PLANNING BOARD AGENDA

CZ-23-01 Buffalo Road: The applicant is requesting to rezone a 138.63-acre tract of land from the R-20A, R-10 and R-8 Residential zoning districts to the R-8 Conditional Zoning district with a master plan consisting of 217 single-family residential lots. The property considered for rezoning is located on the east side of Buffalo Road, approximately 300 south of its intersection with Holland Drive and further identified as Johnston County Tax ID# 14A03005.

Subject: CZ-23-01 Master Plan Comment Questions
CZ-23-01 Buffalo Road

C2.00

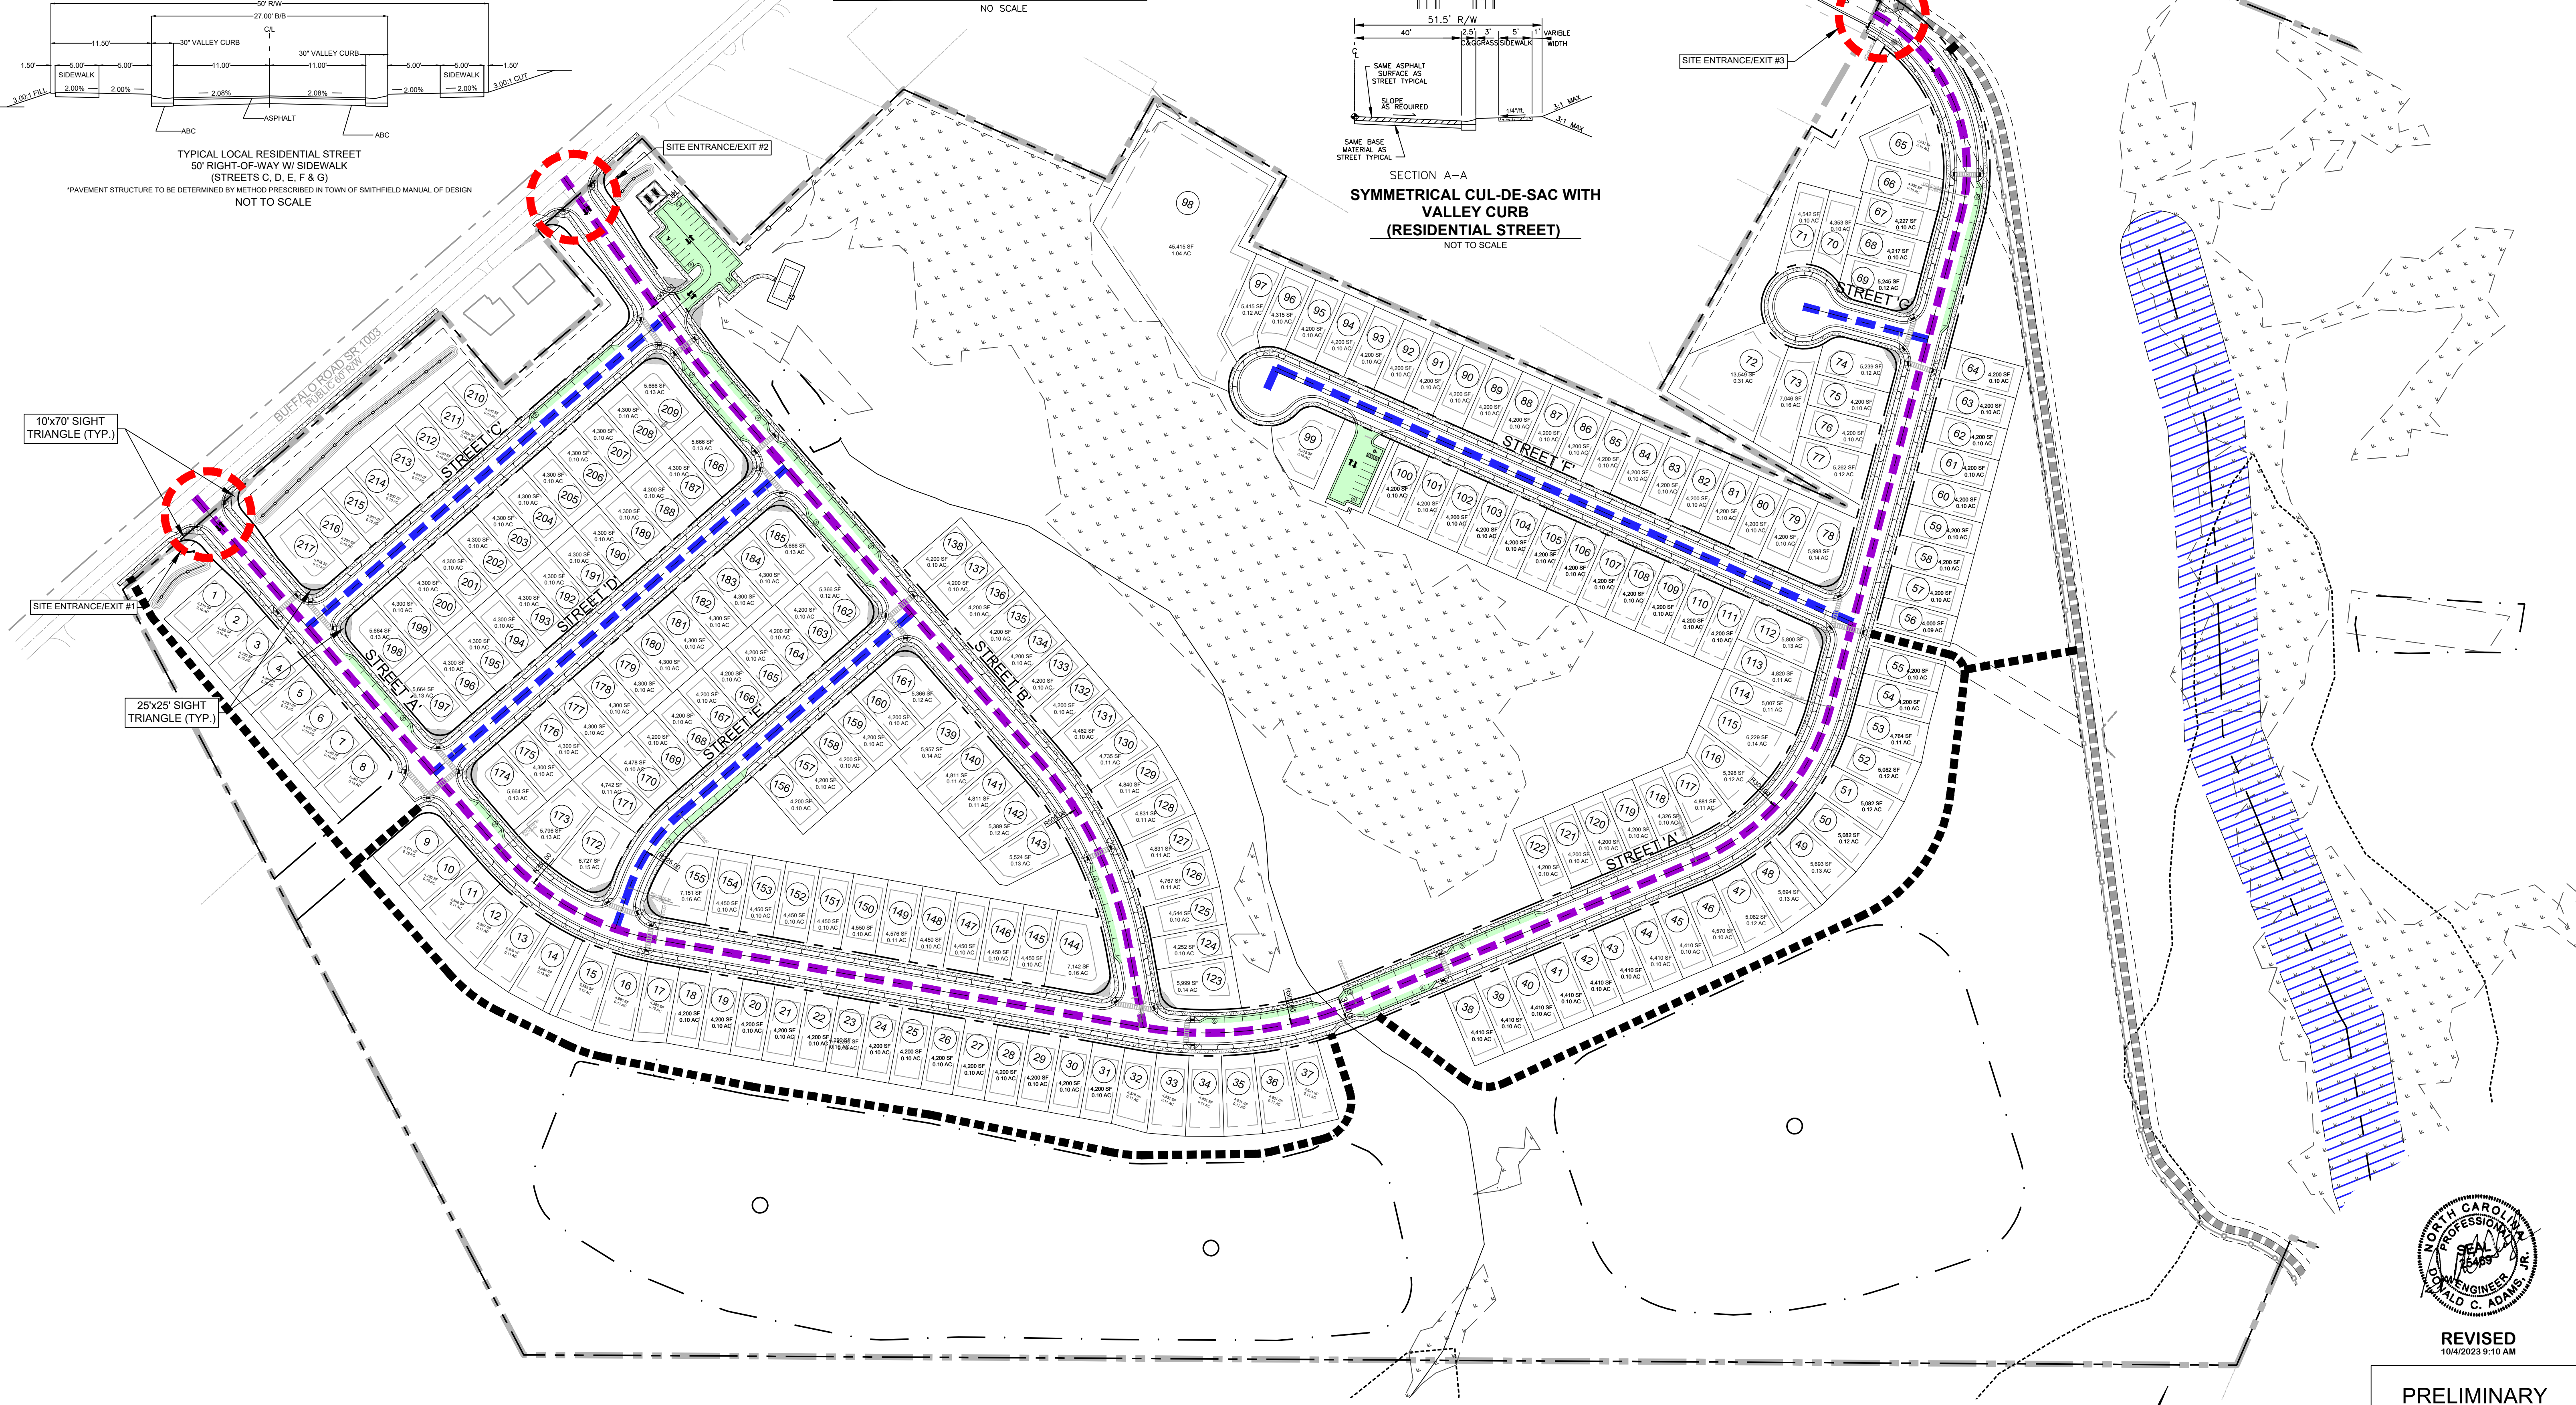
- The masterplan shows a combination of 60' and 50' wide public rights-of-ways. Staff is recommending a minimum width of 60' wide as proposed in the draft Standard Details and Specifications Manual.

- Staff and the Bradford Park residents have a shared concern about potential speeding on the long stretch of Street A. Staff had recommended the developer install round-a-bouts at the intersections to calm traffic. This is not reflected in the submitted plans. Stop signs are often ignored and speed bumps are not preferred by police and fire services.

- A proposed trail will connect Buffalo Road to the Buffalo Creek Greenway through the development. The greenway trail is broken at the creek unnecessarily. This is not a buffered stream, and the trail should be revised to be continuous.

13. Street F exceeds the allowed cul-de-sac length – 750 feet. **We are counting the cul-de-sac length from the intersection of the proposed parking lot on Street F, designed to be a fire apparatus turn-around as well. (See attached blowup.) We believe this meets the intent of the code. Please correct or confirm. This requirement relates to Fire Code, so I would verify the requirement with the Fire Marshal and whether the parking lot satisfies this requirement. Blake Holloman is okay with the parking area to be used for the Fire Apparatus turn-around. Place the parking lot 150 ft or less from the cul-de-sac to reduce 96 ft radius requirement.**

2. All public rights-of-way shall be a minimum of 60' wide.
3. Provide lateral street connections to the Johnson Broadcast Ventures LTD (Tax ID 14075035) and MAC 2008 LLC (Tax ID 14A03007) properties that includes the street and sidewalks.
4. Cul-de-sac bulbs shall have a minimum radius of 48 feet.
5. Provide written architectural standards should be provided to match the example elevations provided on the master plan.
6. Provide a continuous trail between Buffalo Creek Greenway and Buffalo Road.
7. Provide concrete curb and gutter along Buffalo Road (piping the ditch) as allowed by NCDOT.
8. Provide traffic calming for Street A in the form of traffic circles at key intersections.
9. Provide a greater variety of lot widths with larger lots adjacent to the Bradford Park neighborhood.
10. Modify the road connection to Parkway Drive so that it is not a direct connection to Street A.

12. Connect the trails between lot 36 and 37 or provide the reason they cannot be connected. **We need to minimize impact to the stream buffer so a 5' sidewalk will connect on one side through this crossing.**

PRELIMINARY
 LANDSCAPE PLAN

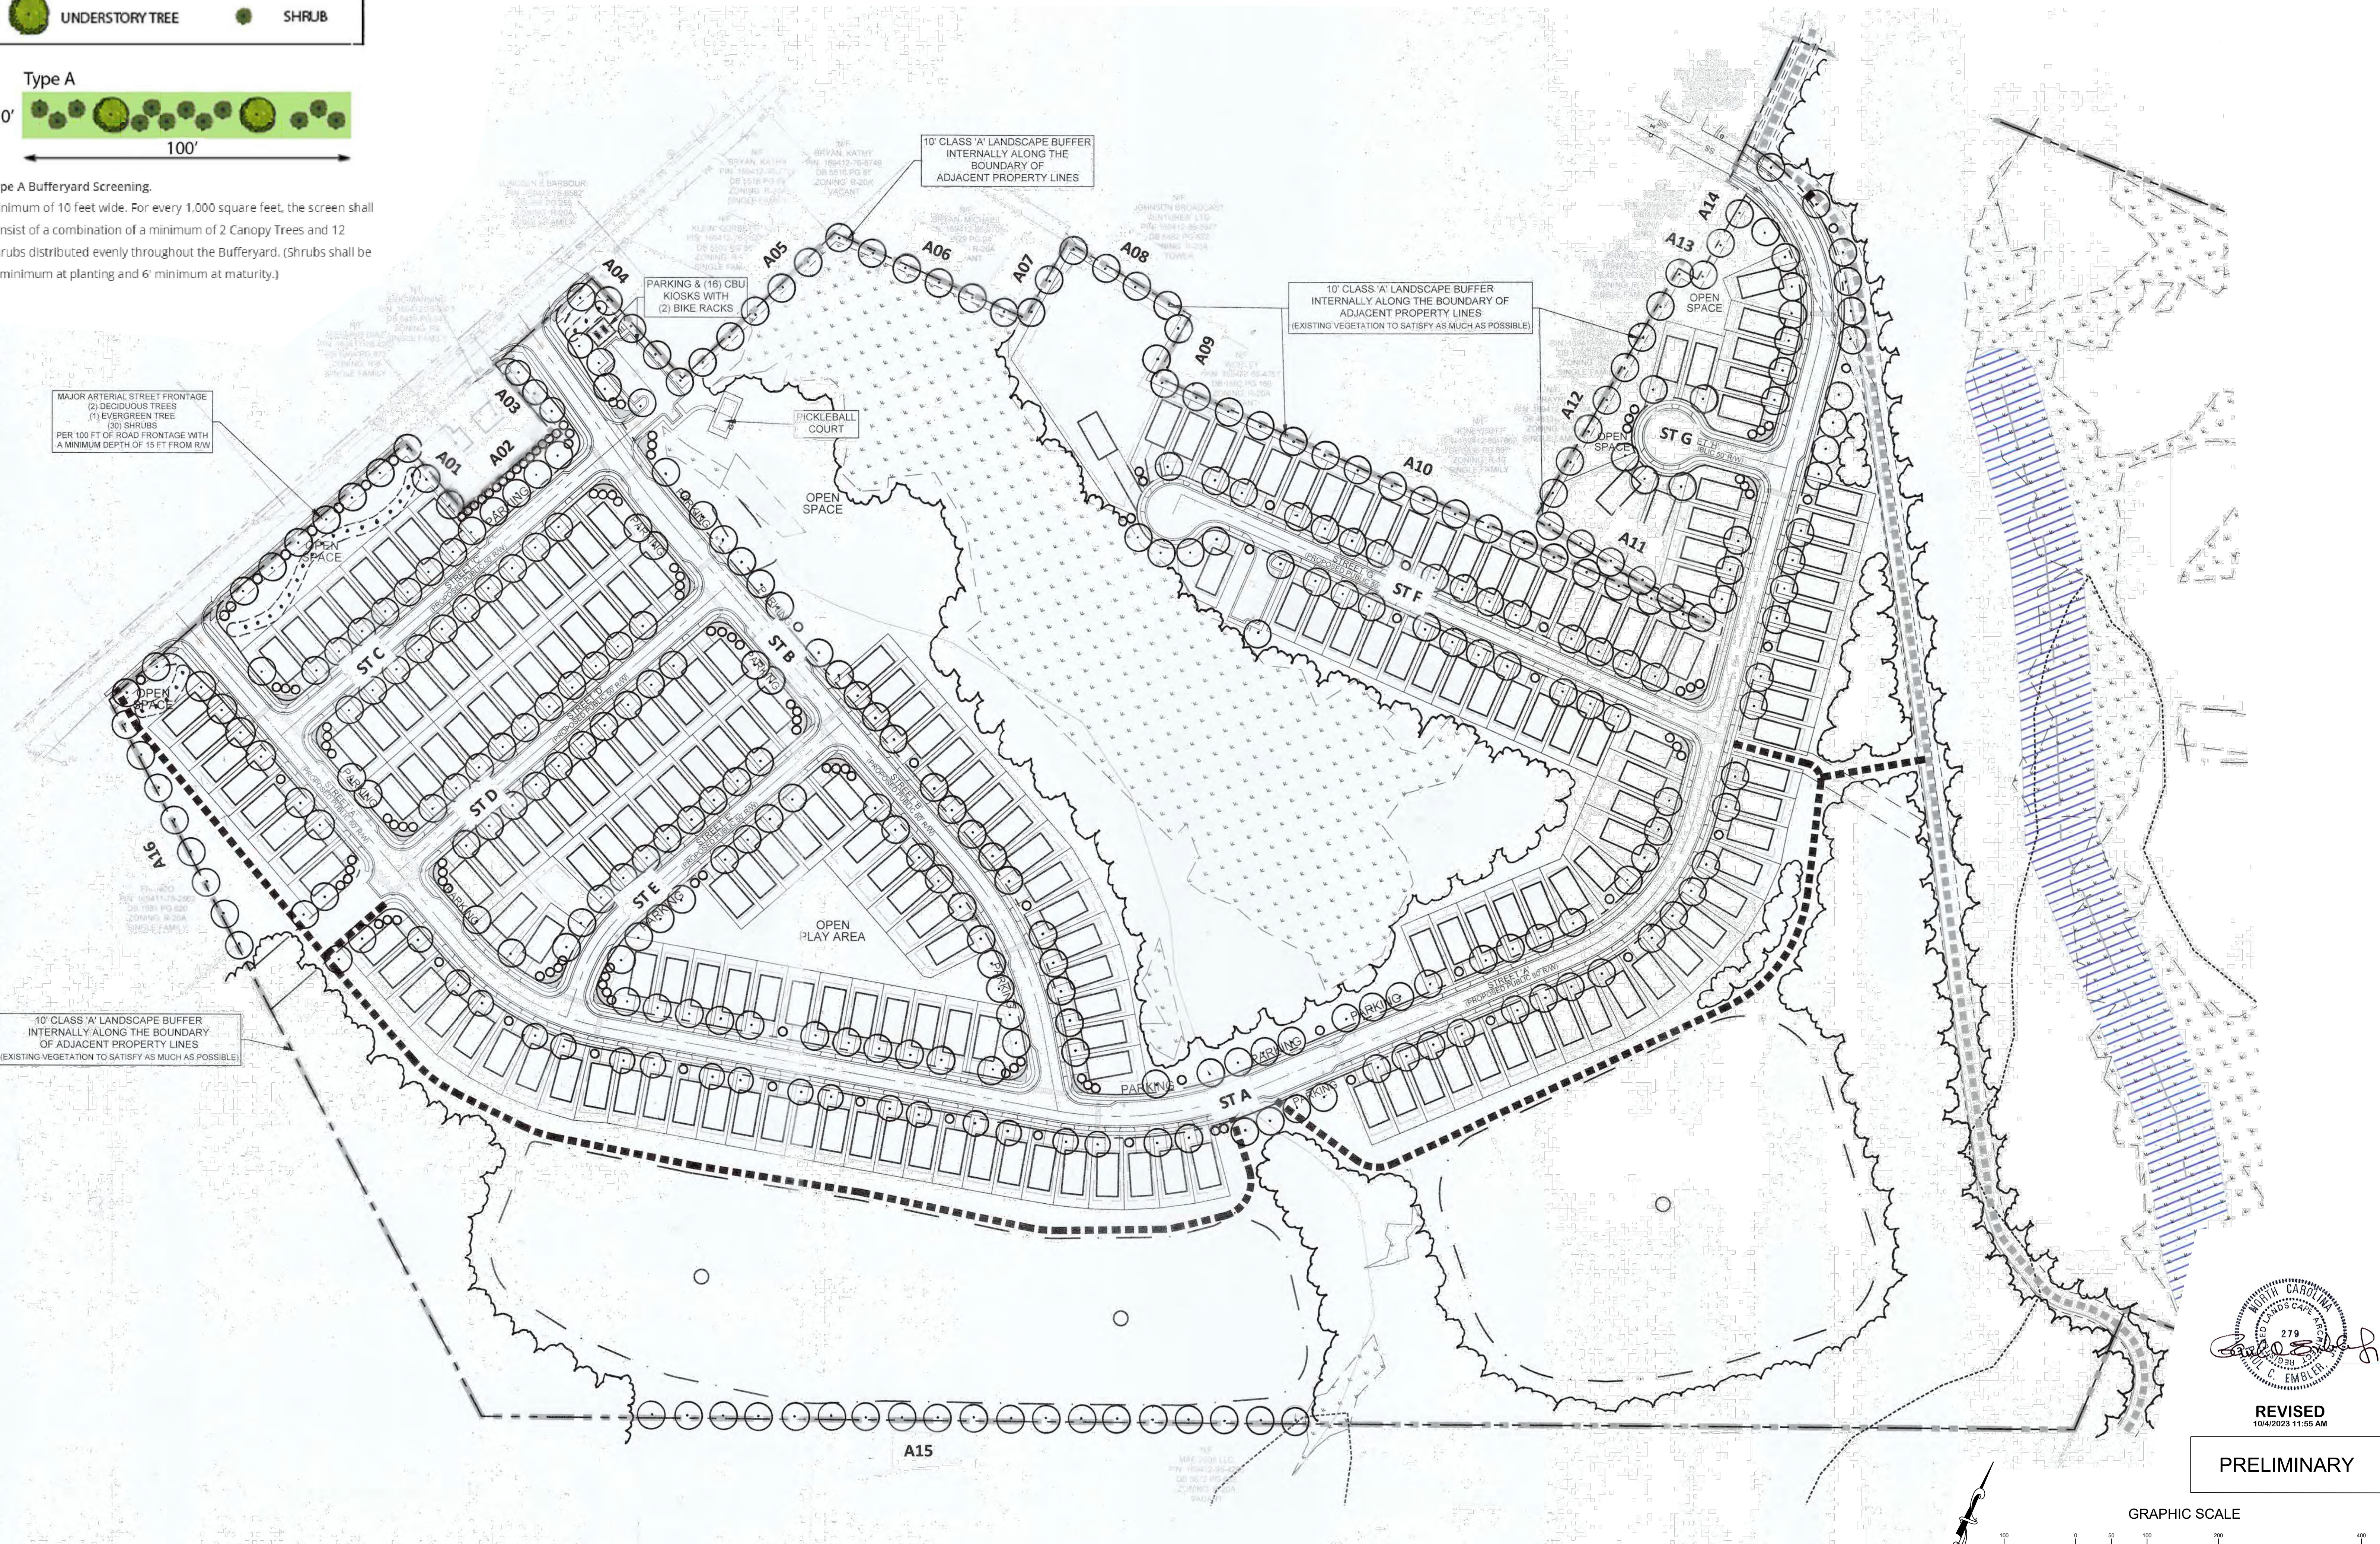
- A Standard Street yard, berm with 6' fence are proposed along Buffalo Road in the common open space. The lots are setback 70 feet from the right-of-way. There is ample room to provide a large berm in this area to screen the backs of the future homes and yards. The developer has provided details of each in the plan set. This is consistent with what has been approved for other developments with conditional zoning.

21. Water meters and catch basins should be located outside of driveways or sidewalks. **Noted.**
22. Show a planted berm with privacy fence with actual plants shown in cross section format. UDO street yard detail is inadequate. **Please specify where a planted berm and fence is required. Is this a requirement or suggestion? If this is a requirement, please direct us to the code/regulation so we may address this completely. Suggestion. This is conditional zoning and we will be suggesting this as a condition of approval. The Town Council has been very clear in other past projects that they do not want to see the back yards of houses from the street. A planting berm has been added with evergreen plants and a fence.**

- TO PROVIDE ADDITIONAL SCREENING AND BUFFERING ALONG BUFFALO ROAD IN ADDITION TO THE ARTERIAL BUFFER YARD PLANTINGS, A LANDSCAPED FOUR FOOT HIGH BERM WILL BE CONSTRUCTED AND WILL INCORPORATE A ORNAMENTAL SCREEN FENCE THE LENGTH OF THE BERM. SEE ATTACHED DETAIL.
